## ADDENDUM NO. 1, September 30, 2020 *(Revised October 1, 2020)*

RE: POK-DIP 151C  
Project No. 2190380.01

FROM: **Mackenzie**  
The Hudson Building  
101 E 6<sup>th</sup> Street, #200  
Vancouver, WA 98660  
(360) 695-7879

1  
A4.10  
1/4"=1'-0"

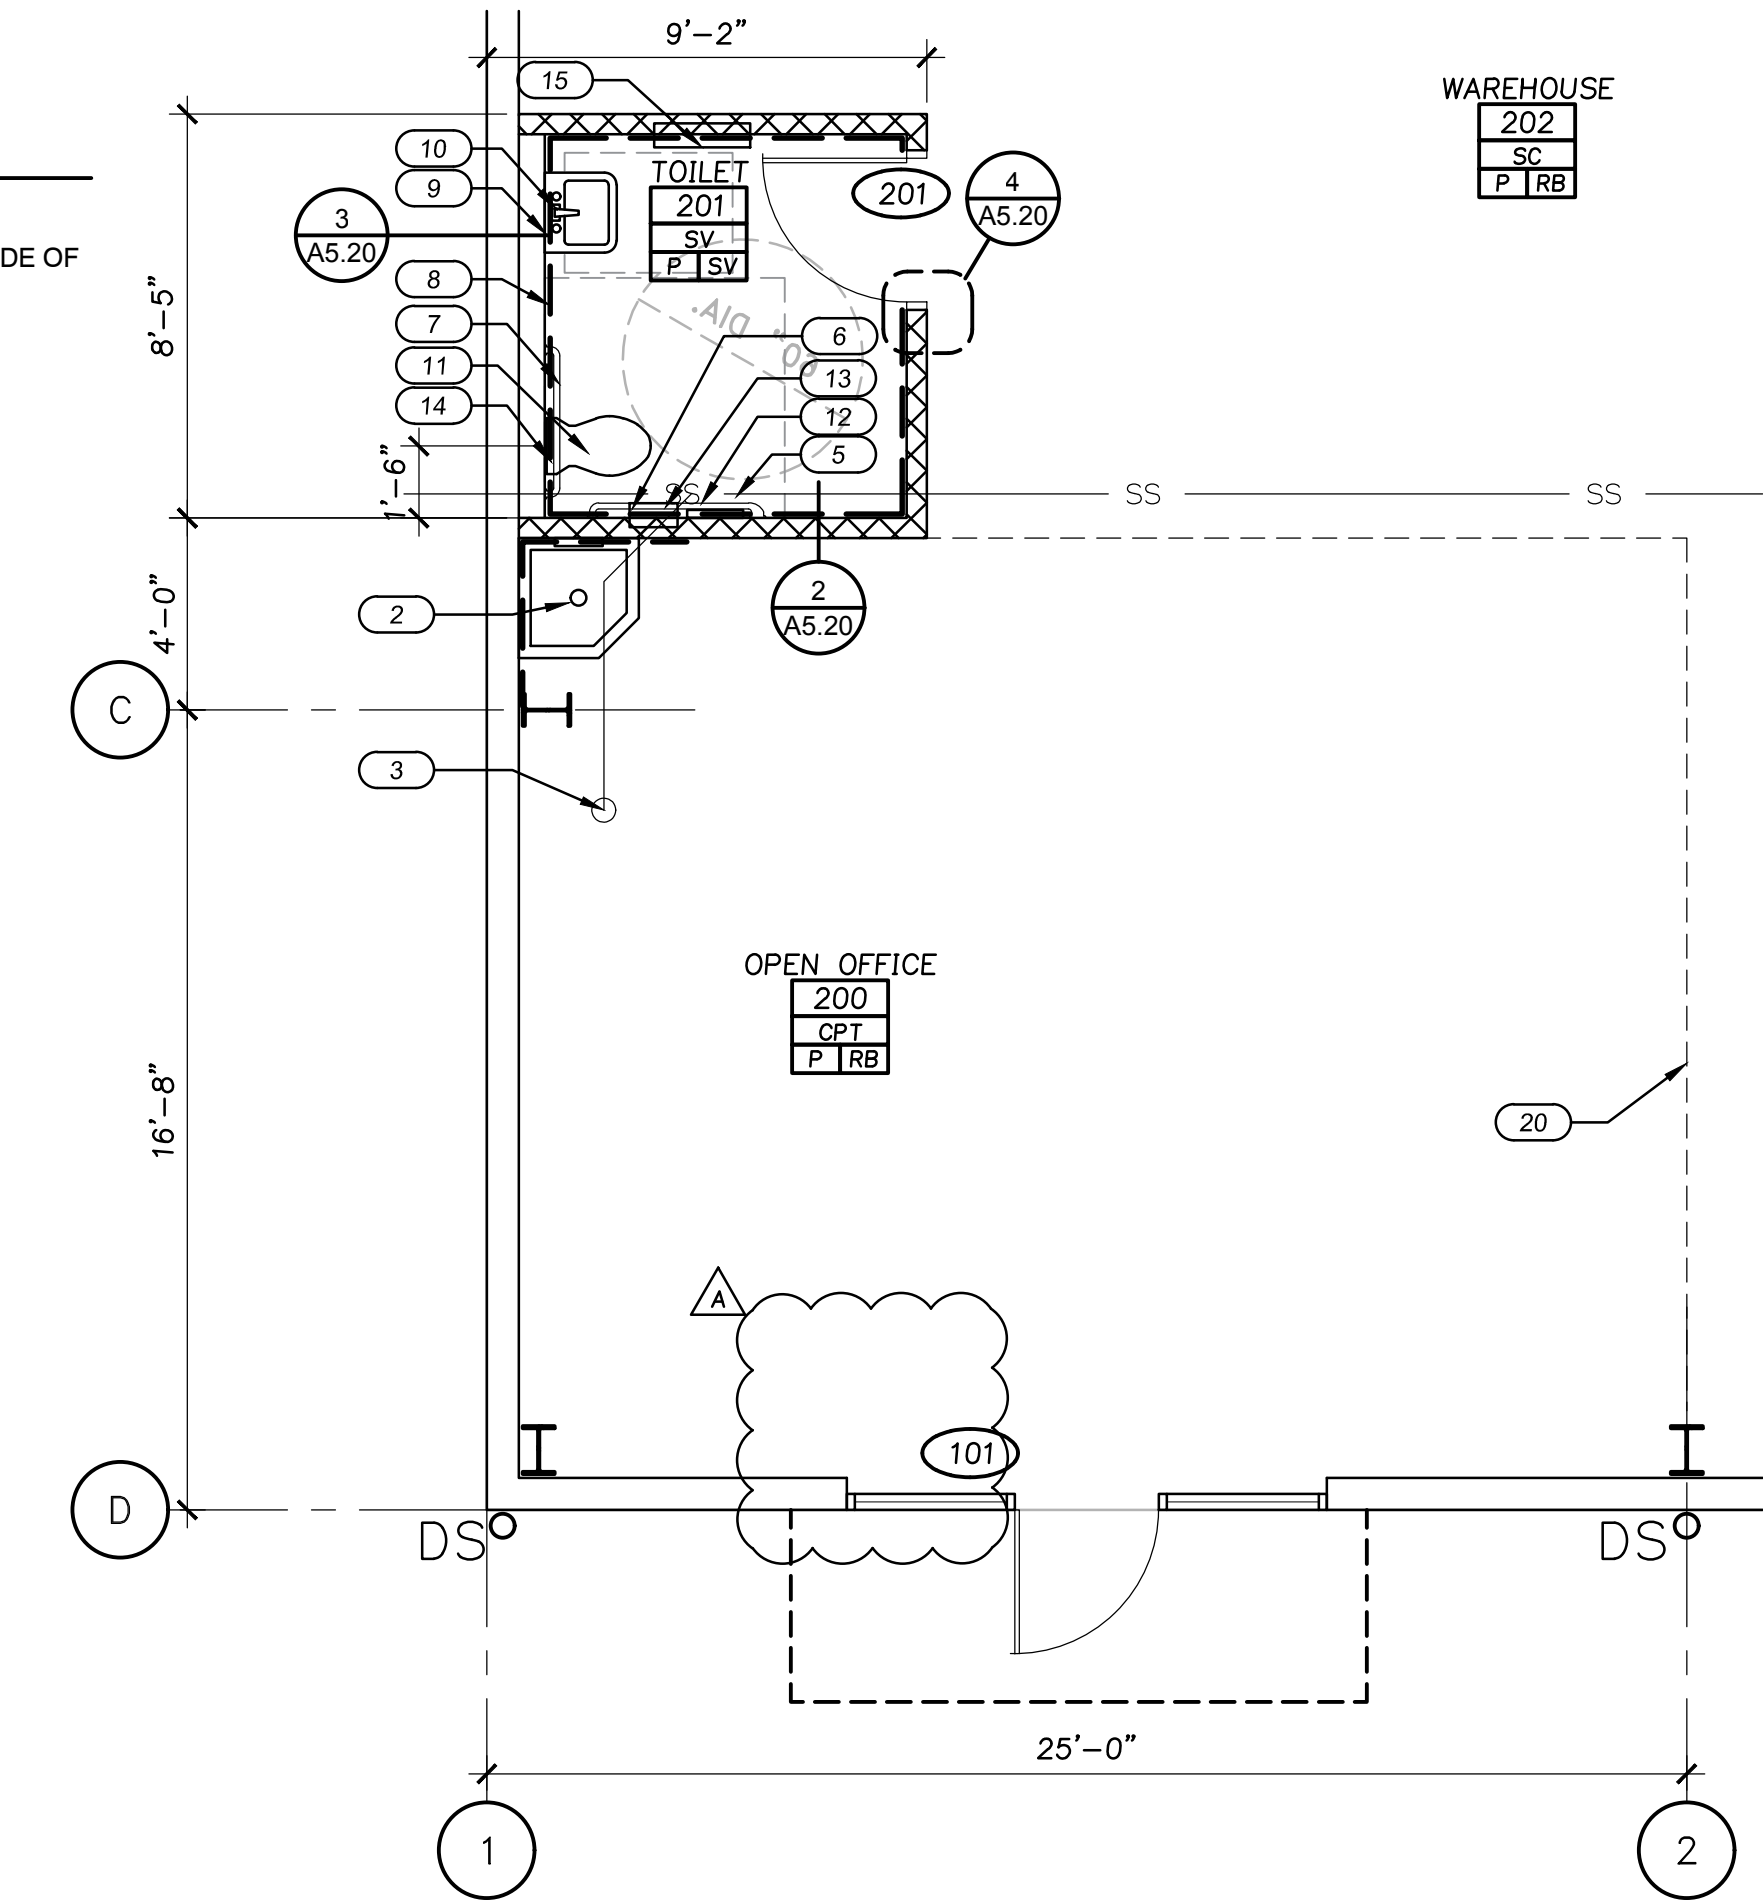
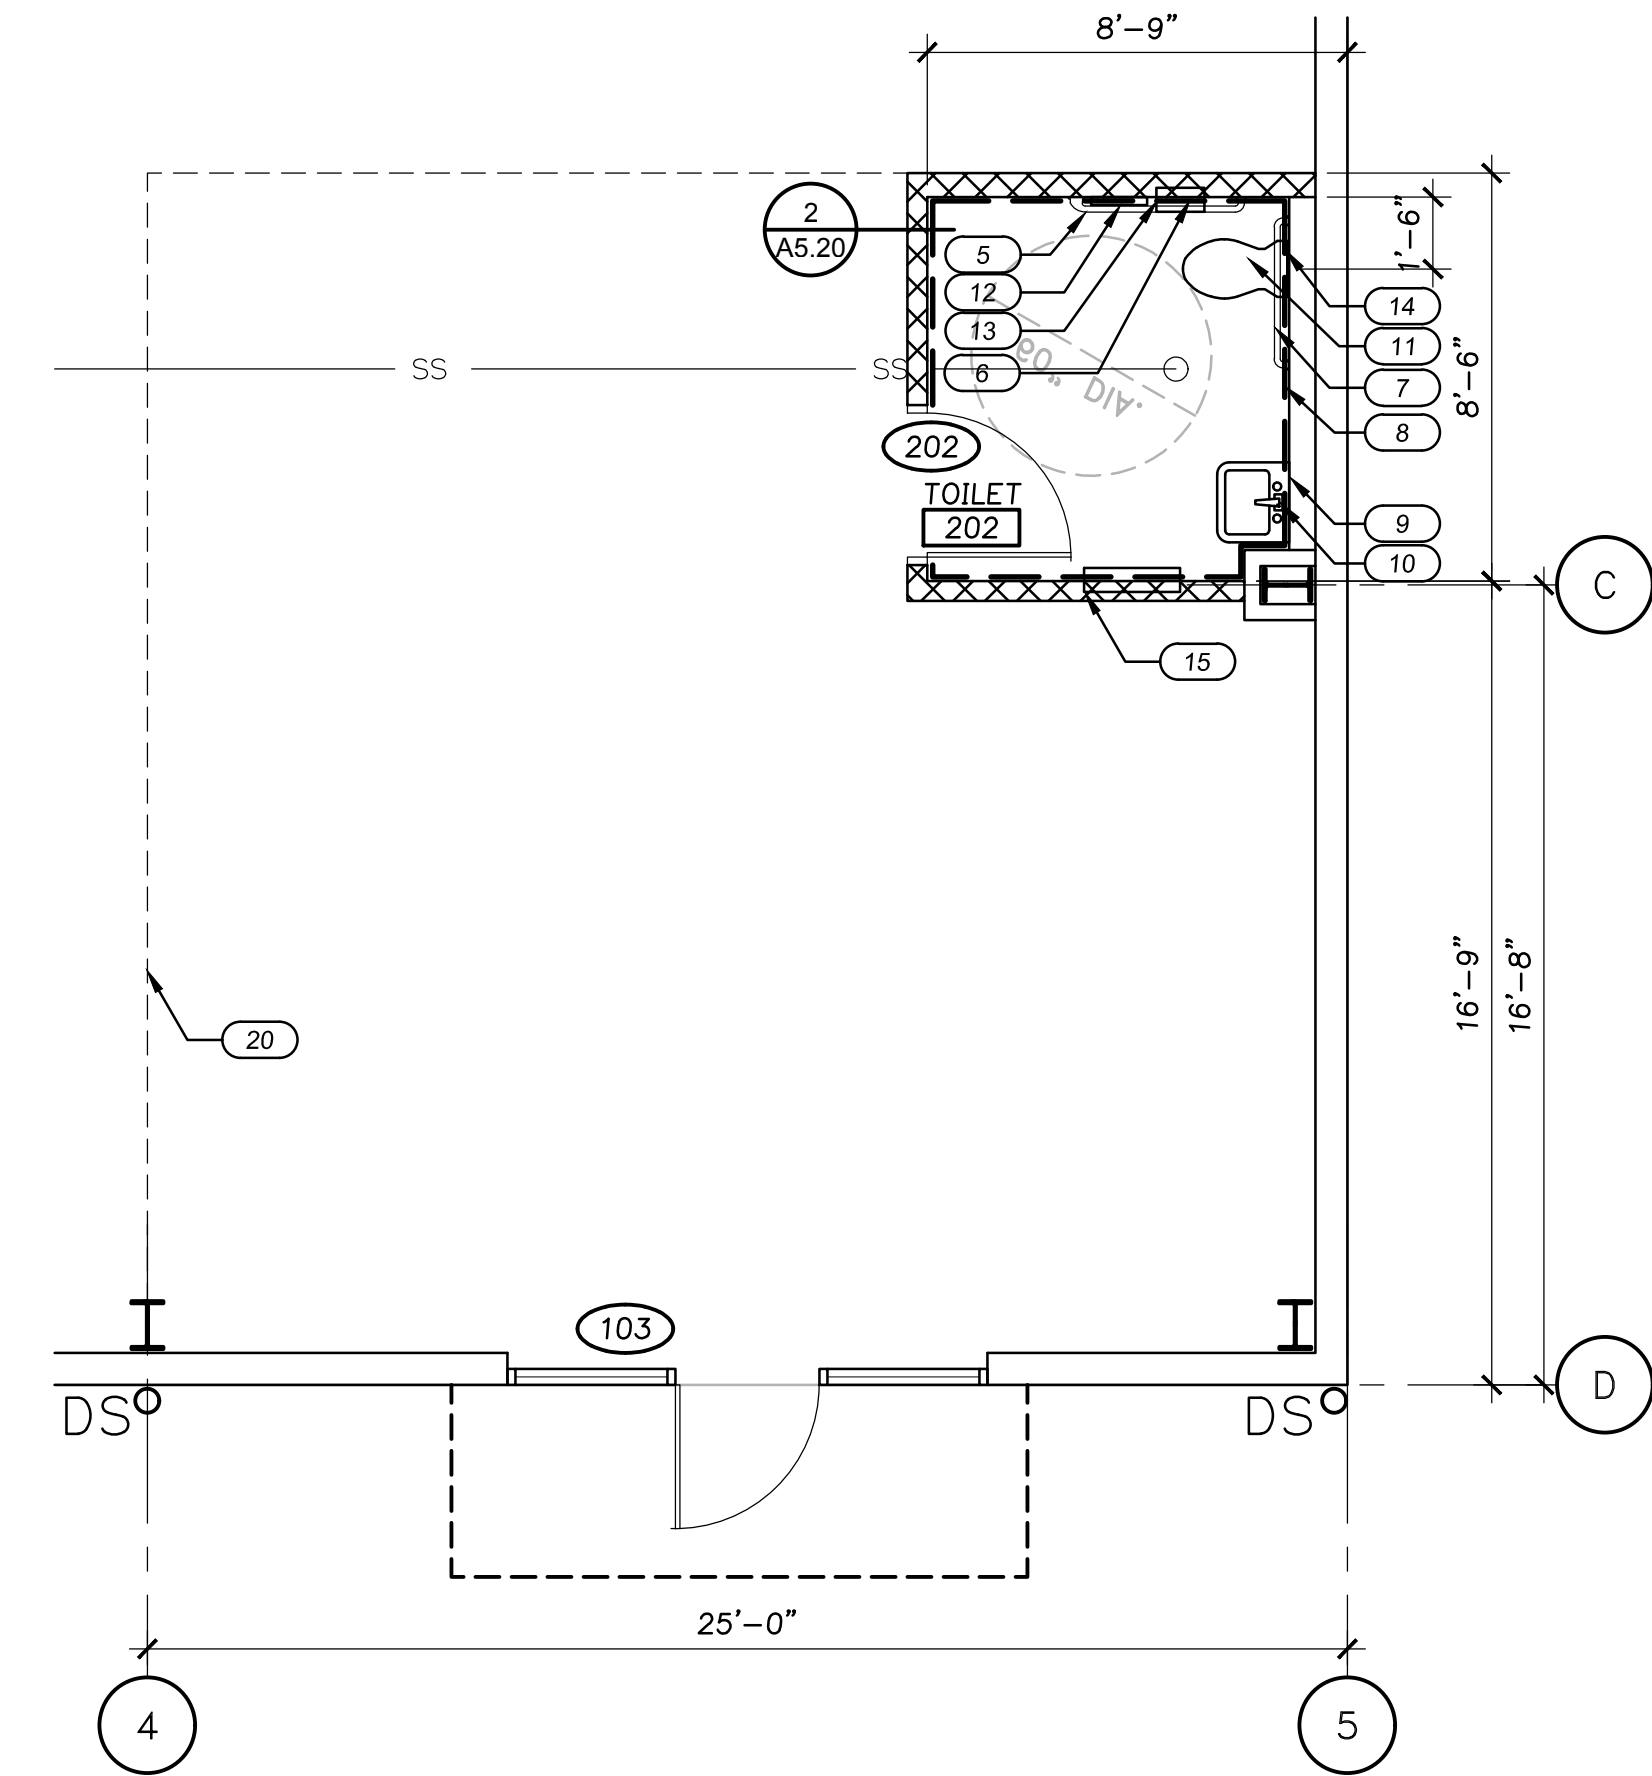
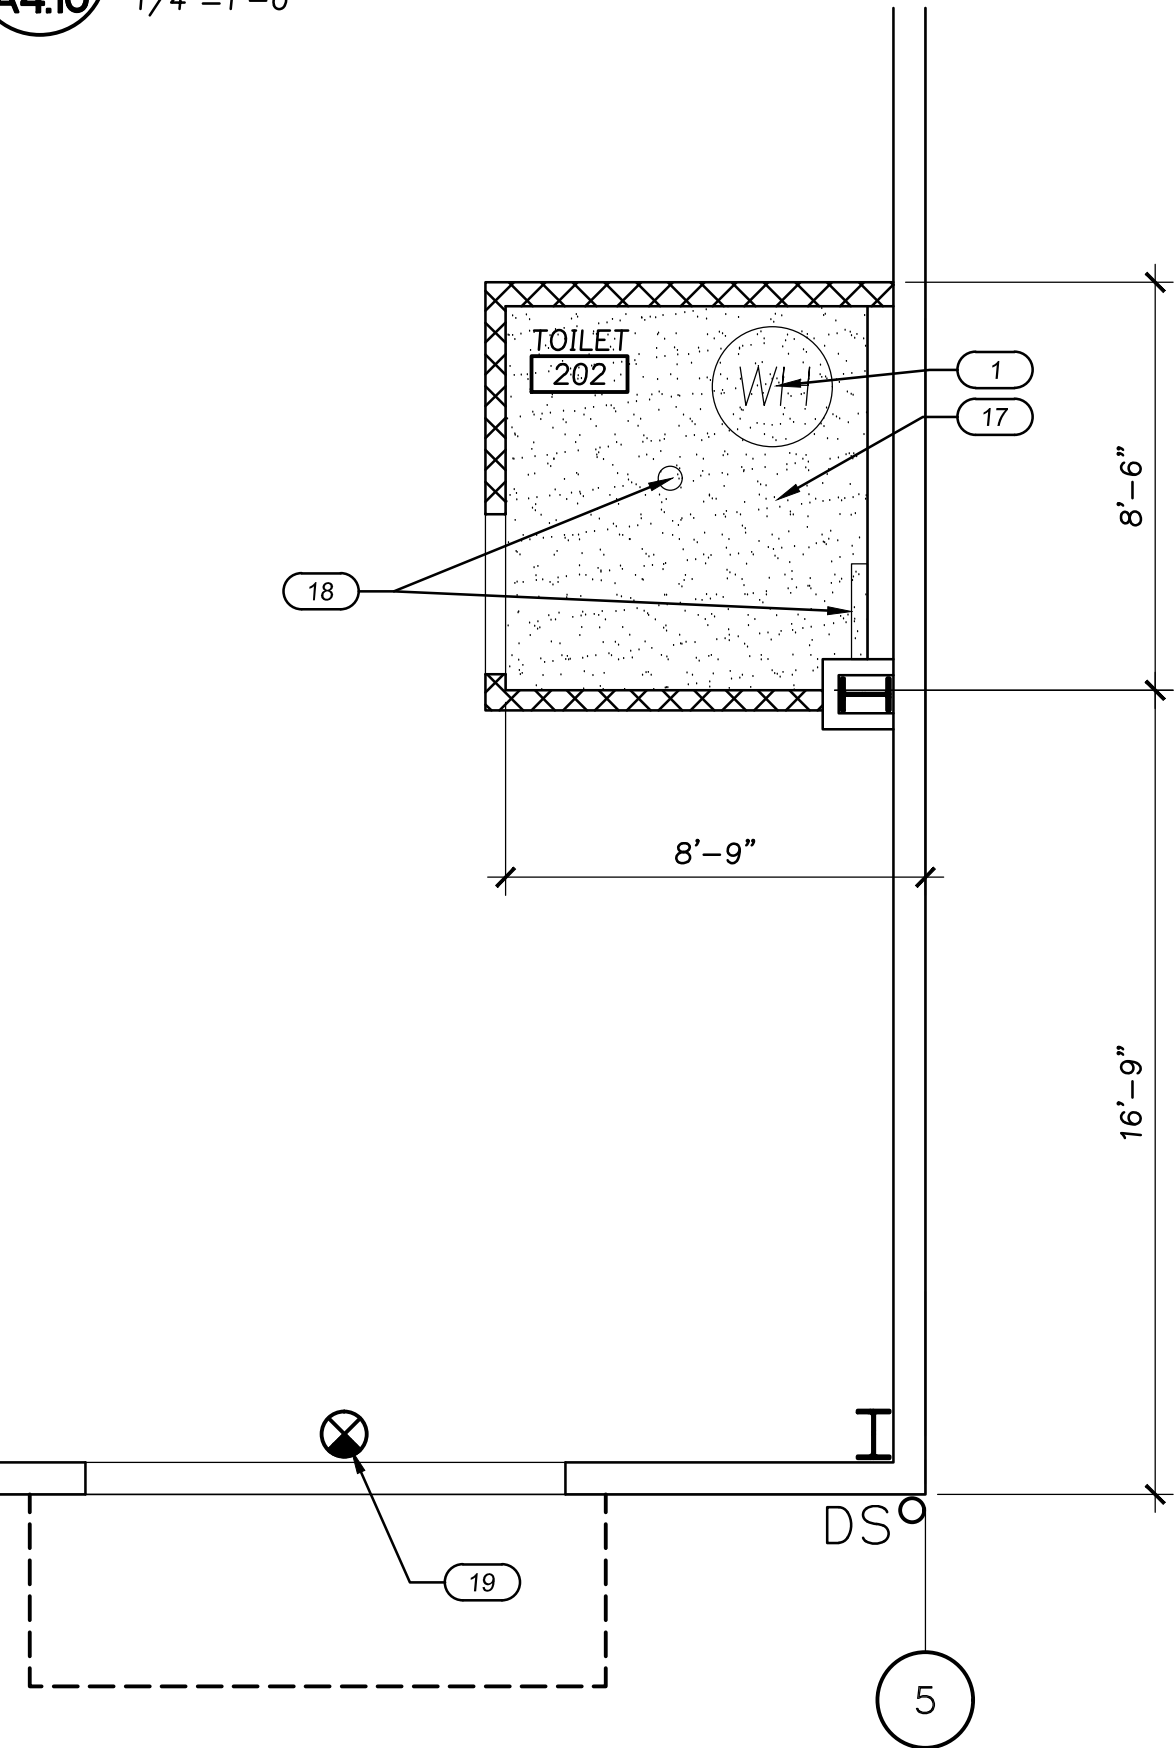
- A. Bid Form adjusted removing additive and deductive items. Separate alternates form to be submitted (GC standard alternate format).
45. Drawing A4.10, enlarged office plan shows detail 7/A5.20 but this detail does not exist on A5.20, please verify.

- A. Detail callout removed.
46. Drawing A4.10, keynote 16, where is this applicable?
- A. Keynote removed, ACT to be provided with future tenant improvements.

| ARCHITECTURAL DOCUMENT CHANGE LOG                                                          |                |               |               |                               |              | Mackenzie<br>1515 SE Water Ave, Ste 100, Portland OR 97214 (503) 224-9560                                                                                                                                                                                                                                                                               |
|--------------------------------------------------------------------------------------------|----------------|---------------|---------------|-------------------------------|--------------|---------------------------------------------------------------------------------------------------------------------------------------------------------------------------------------------------------------------------------------------------------------------------------------------------------------------------------------------------------|
| A4.10                                                                                      | ADDENDUM #1    | A             | 9/30/2020     | 3                             | 1,2,3        | REMOVED RCP NOTES, A, B, C, D, AND F. REMOVED KEYNOTE 16. REMOVED DETAIL 7/A5.20 TAG.                                                                                                                                                                                                                                                                   |
